REQUEST FOR INFORMATION

Project Name: KINDRED RESORT

Hardscapes Snowmelt Insulation

Kindred Resort @ Keystone
RFI-01245 Revision 0
response issued_04/26/2024

SHEET TITLE:
GARAGE MECHANICAL
PLAN - AREA D

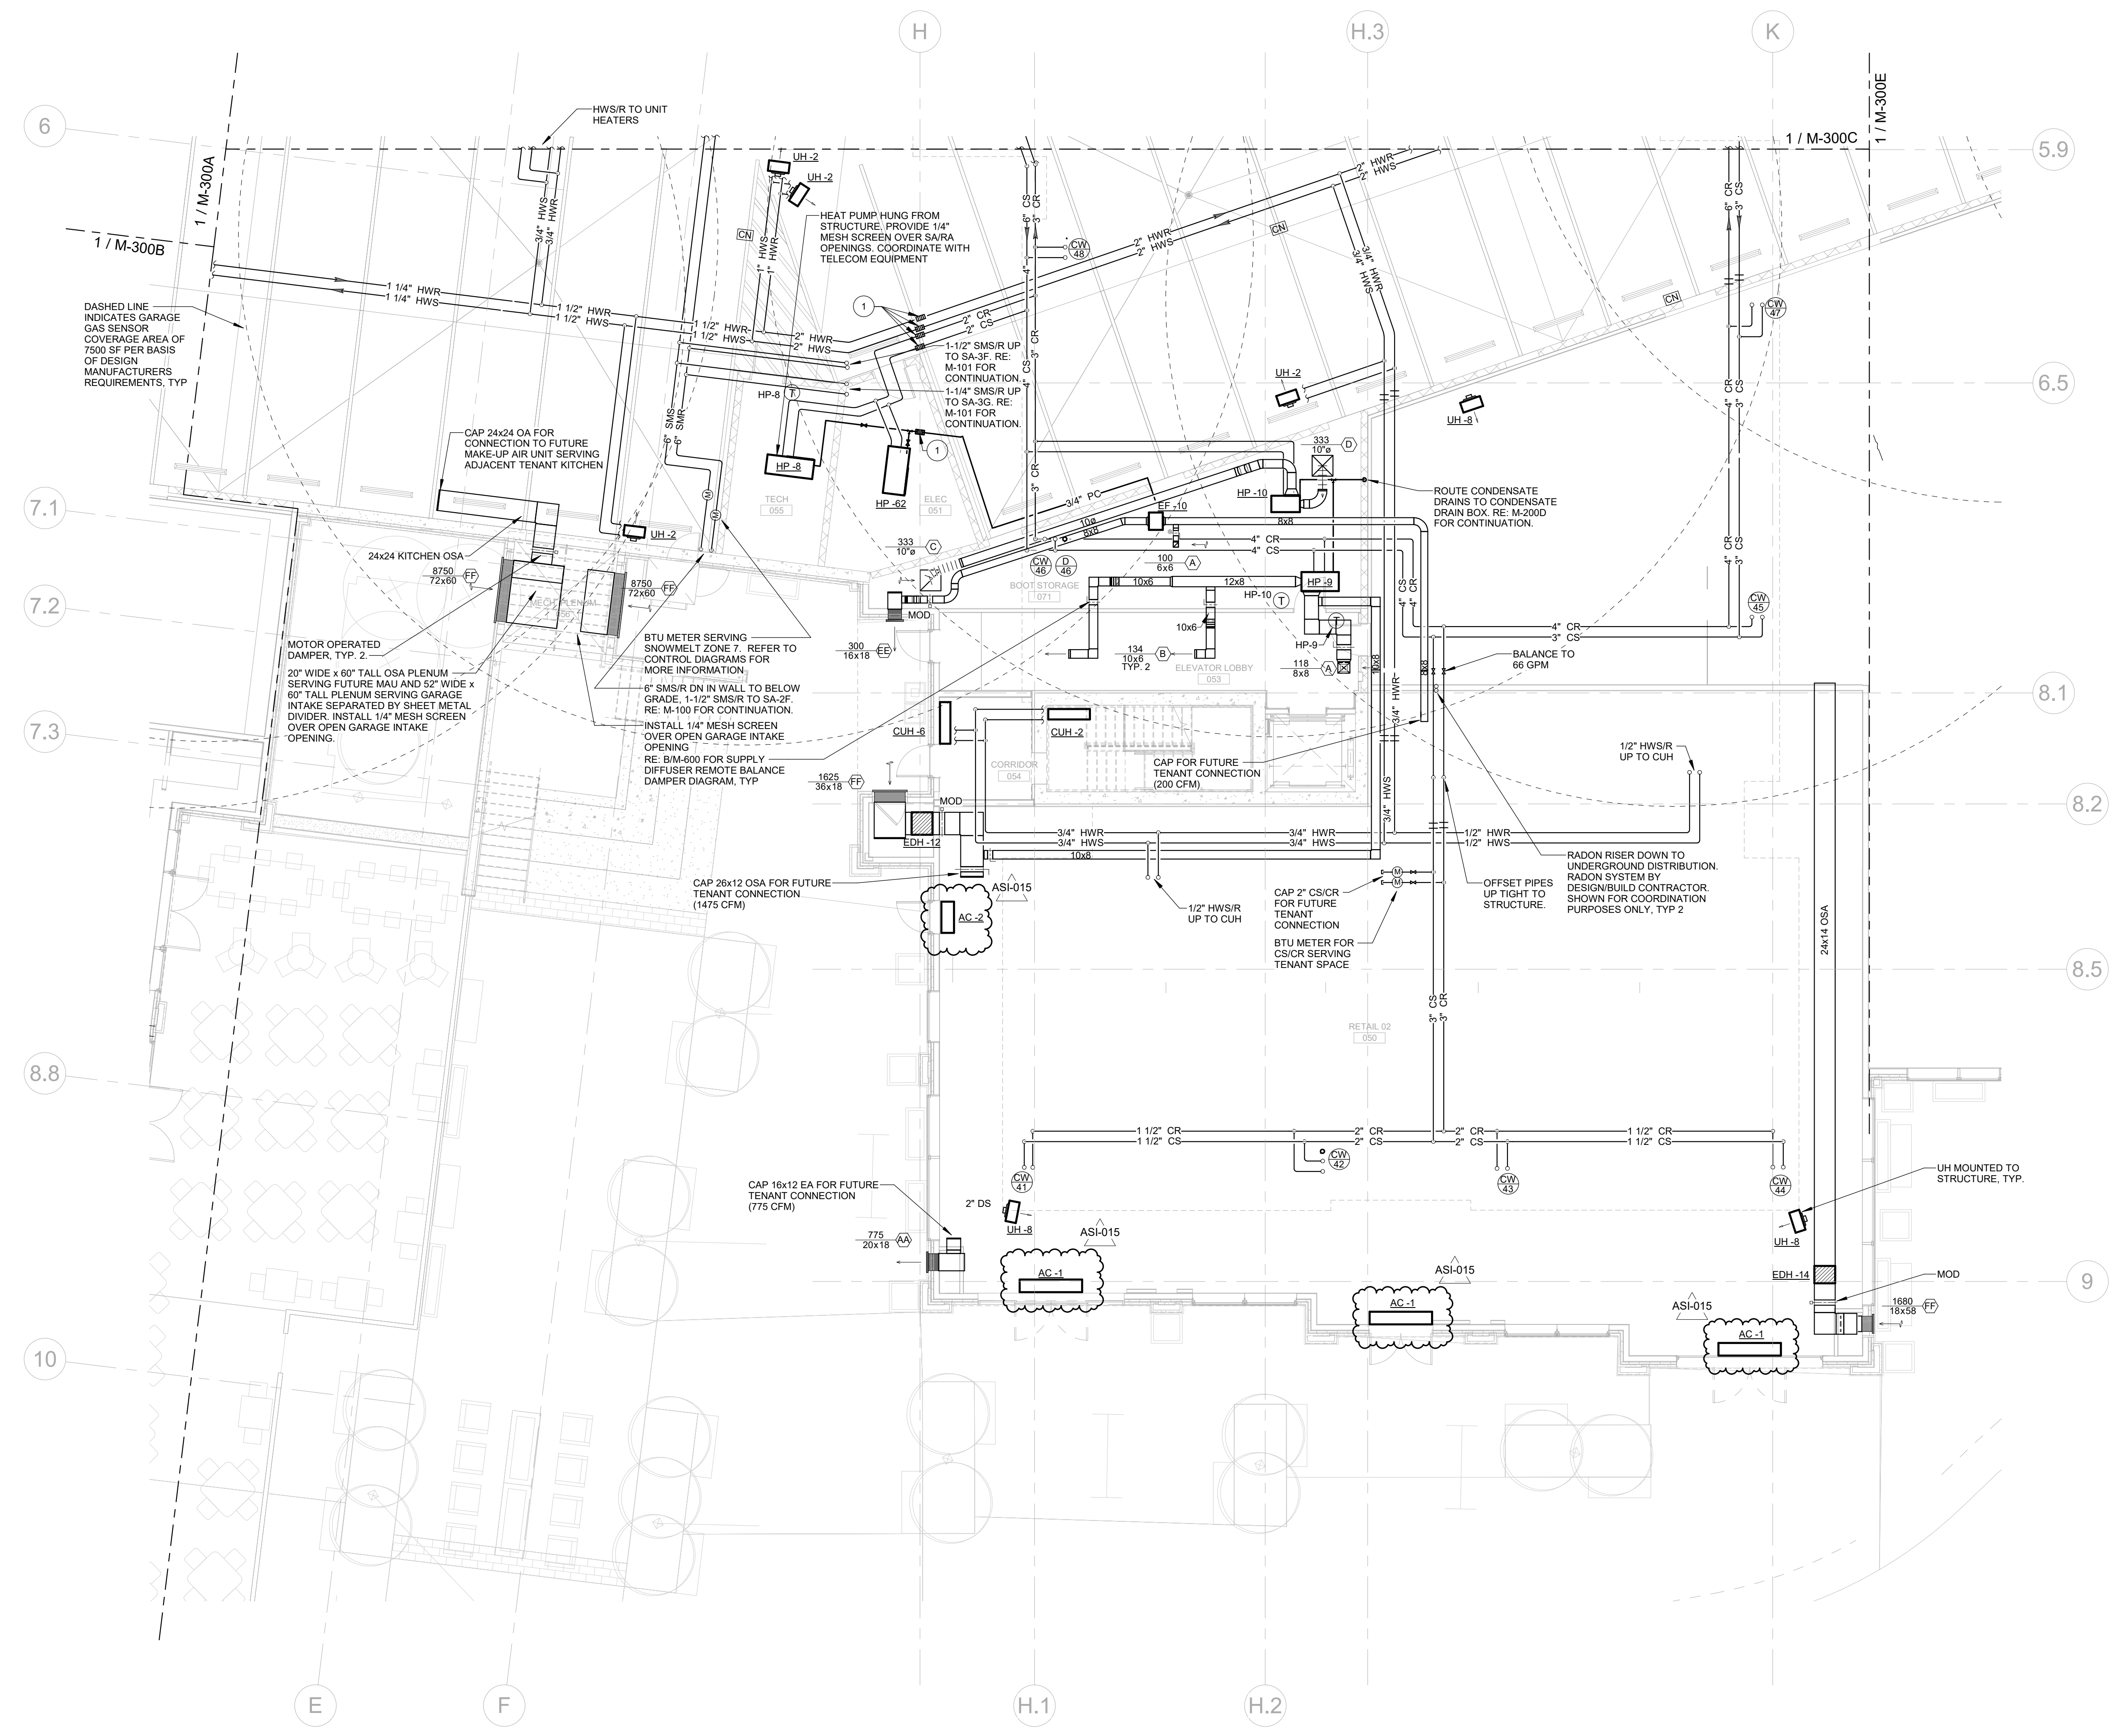
[Submitted: 6/21/2024 by Ryan Bell, PCL Construction Services, Inc. Rev #0]
 ASI-15 was issued with new air curtains, automatic sliding doors and electrical panel upgrades. In further correspondence with ownership, Vail Resorts intends to provide their own air curtains, panels and make electrical upgrades as needed under their TI permit. However, the added sliding doors in the Ski Restaurant 066 and Retail 02 area will still be in PCL's scope of work and therefore the added power to these doors (Identified on E-200B and E-200D) will need to remain in place. As a result of these changes please provide updated mechanical and electrical drawings that reflect the scope of work pertaining to PCL including removing the air curtain and panels from plan sheets and schedules.

Pages to Revise: M-003, M-300D, E-001, E-003, E-004, E-005, E-006, E-008 and E-200D.

Also, ASI-015 is revised to incorporate these updated sheets and will be reissued as ASI-015r1 under separate cover to the AHJ.

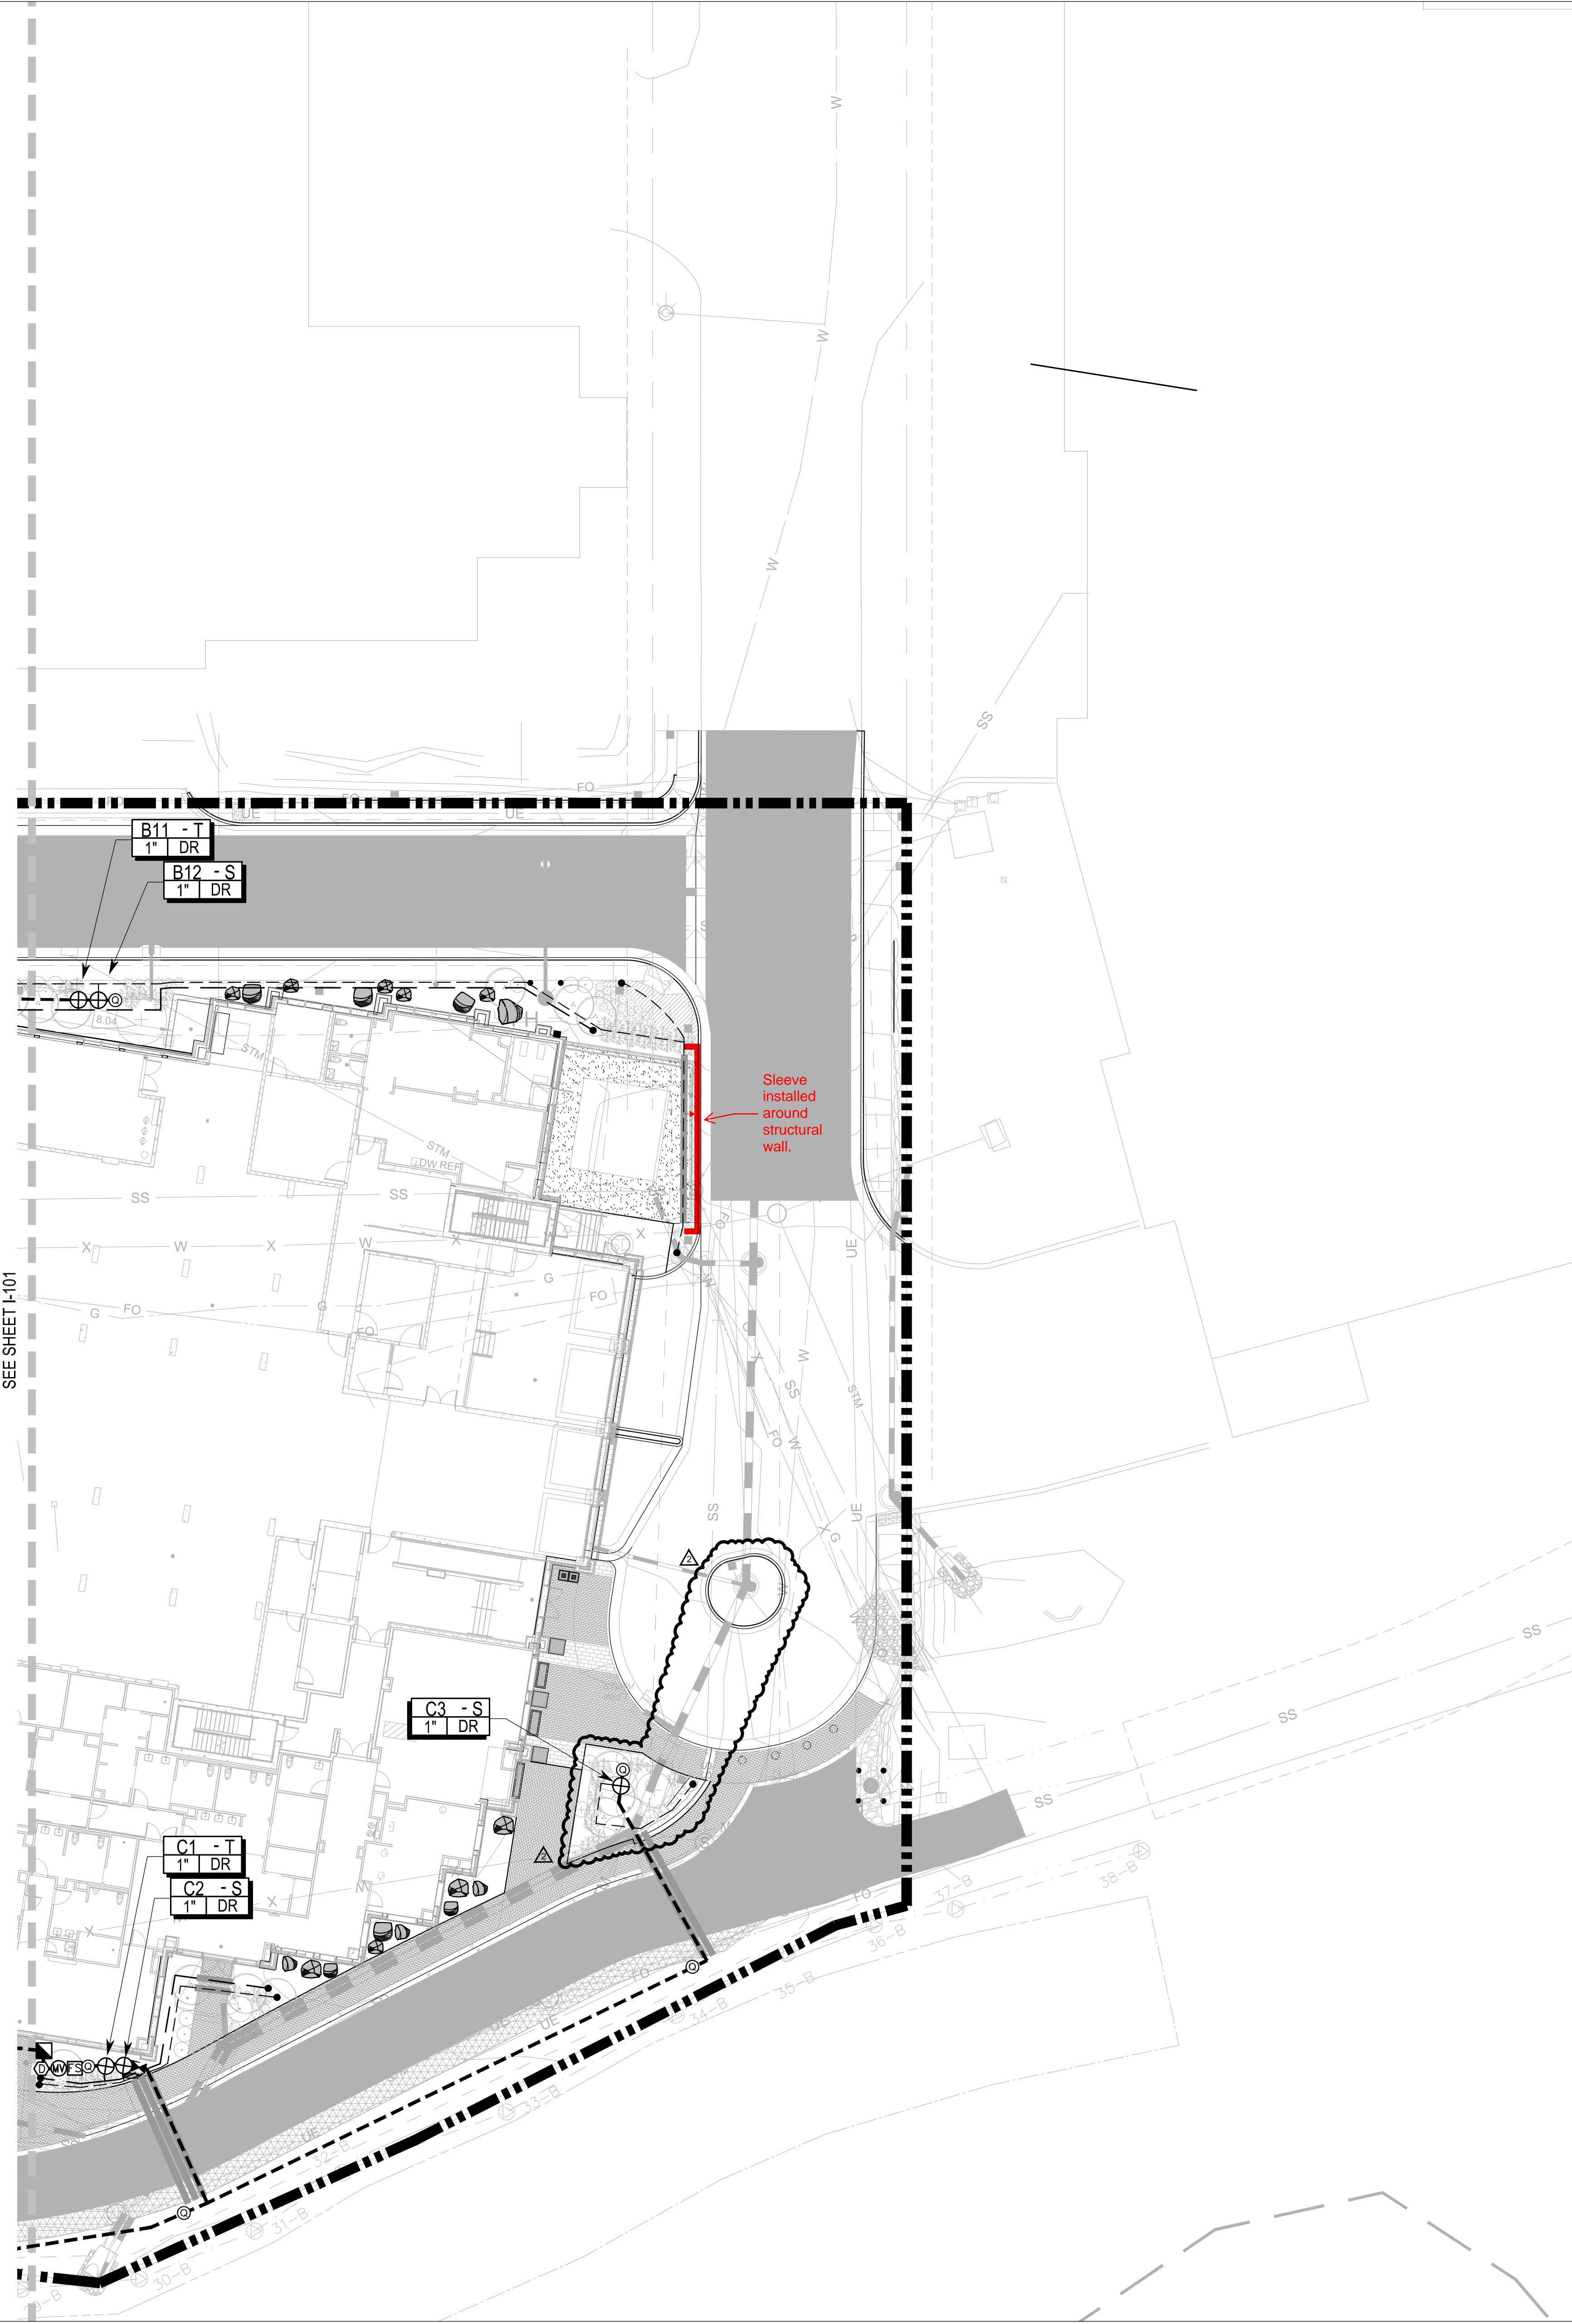
1. Landscaping sleeving is called out to be 3" PVC on Drawing I-001. The irrigation drawings call for the mainline to be 1" class 200 BE PVC pipe per detail I-302/1. Several 3" PVC sleeves were required to have 90-degree bends to accommodate site conditions. In order to accommodate the 90-degree sleeving, please confirm if it is acceptable to change the mainline piping to 1" polyethylene piping.

See attached markup showing where 90-degree sleeves were installed. An urgent response is requested to continue with subsequent activities for the irrigation scope.

1. The irrigation lines in question/noted on the markup are 3/4" polyethylene drip laterals and do not require a substitution. If 90 degree sleeves are required, they should be sweep elbows.
